Title:                   Advisory Committee on Reactor Safeguards  
                          NuScale Subcommittee: Open Session

Date:                  Tuesday, February 4, 2020

"ACRS Subcommittee Presentation: NuScale FSAR – Steam Generator Design," PM-0220-68568,  
Revision 0

## Steam Generator Program inspections

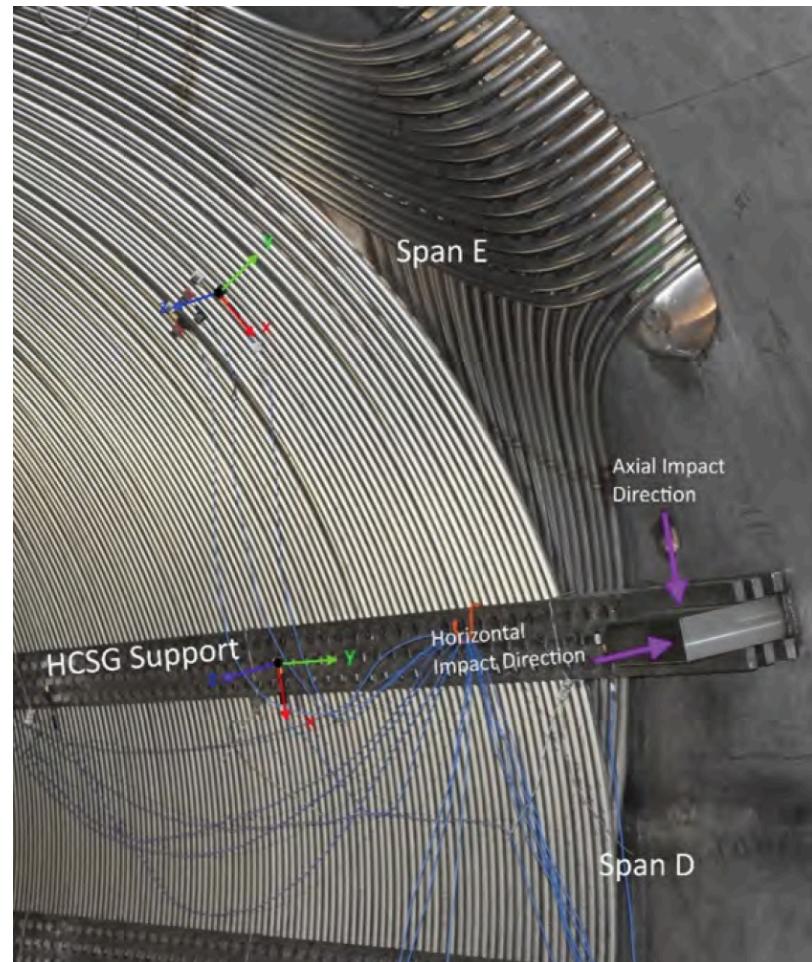
- Tubes inspected from the inside with eddy current testing (ET)
  - Internal and external volumetric degradation (corrosion, wear)
  - Internal and external cracking
- Cracking – plug tube when detected (some plants have exceptions through license amendment)
- Wear from support structures and foreign objects managed based on the cause, ET characterization, and projected growth
- Visual examination on the shell side (tubes, supports, deposits)
- NuScale program described in FSAR Section 5.4.1.6

# Staff's Evaluation: SG Inlet Flow Restrictor

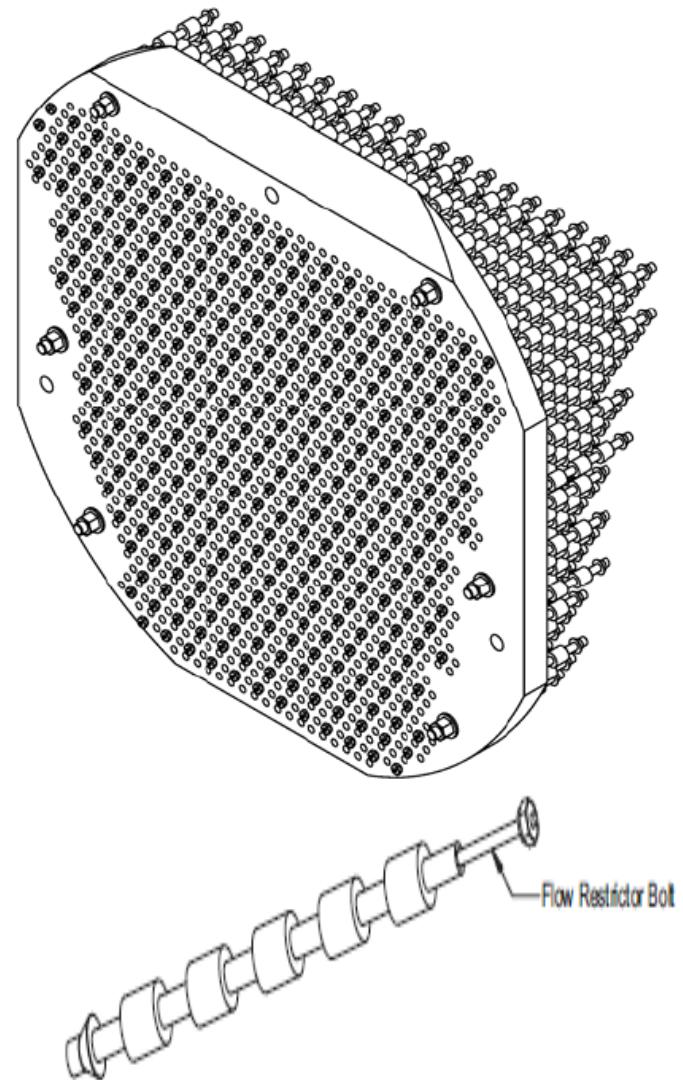
- Mechanisms evaluated:
  - Leakage flow instability (LFI)
- Design concepts evaluated by tests
  - Significant margin against LFI
- Final design to be validated with testing prior to initial startup
  - Test plan and acceptance criteria described in comprehensive vibration assessment program (CVAP) Measurement and Inspection Plan Technical Report
    - Plan and criteria are acceptable

# Staff's Evaluation: DWO FIV

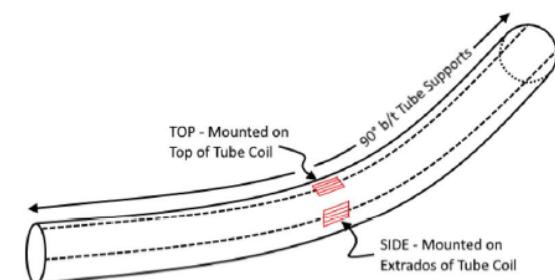
- Density wave oscillation (DWO) observed in TF-2 testing
  - Temperature and flow oscillations in secondary coolant
- TF-2 tubes instrumented with strain gages
- Very long oscillation period
  - Frequency very low
    - DWO will not excite HCSG structural resonances
- Surface strain fluctuations on the order of hundreds of microstrain
  - Alternating stress intensities appear to be below fatigue endurance limit (ASME calculations performed under ITAAC will provide final confirmation)
  - Max surface stresses are below yield and ultimate strengths

# Staff's Evaluation: DWO Wear

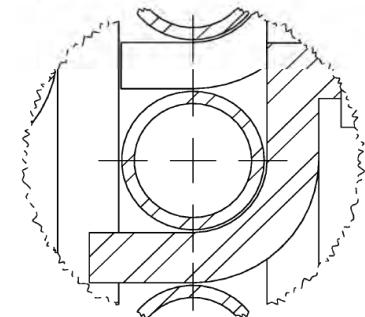
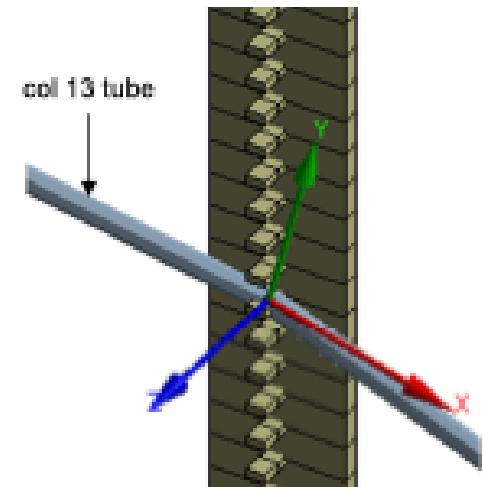
- Sliding and wear
  - Oscillating thermal loading could cause tubing to expand and contract, leading to sliding along the tube support tabs
  - Long term wear will be monitored by steam generator program inspections
